Access Compliance Report Public Rights-of-Way (Curb Ramps)

Main Street: TIGERTAIL_DR Cross Street: FOSTER_RD Location: NW

ADA ID: RPRK211207124905 Ramp Type: Type 1 - Perpendicular Diagonal Initial Pass/Fail: Pass Overall Compliance: No Severity Score: 0

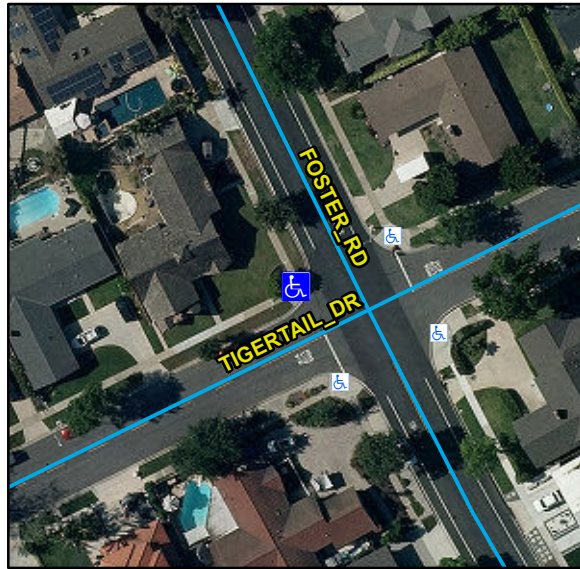
R304.2.2, R304.2.1, R304.5.3, STD 1115

Remove & Replace Curb Ramp With Two New Directional Ramps or Equivalent. Remove & Replace Gutter.
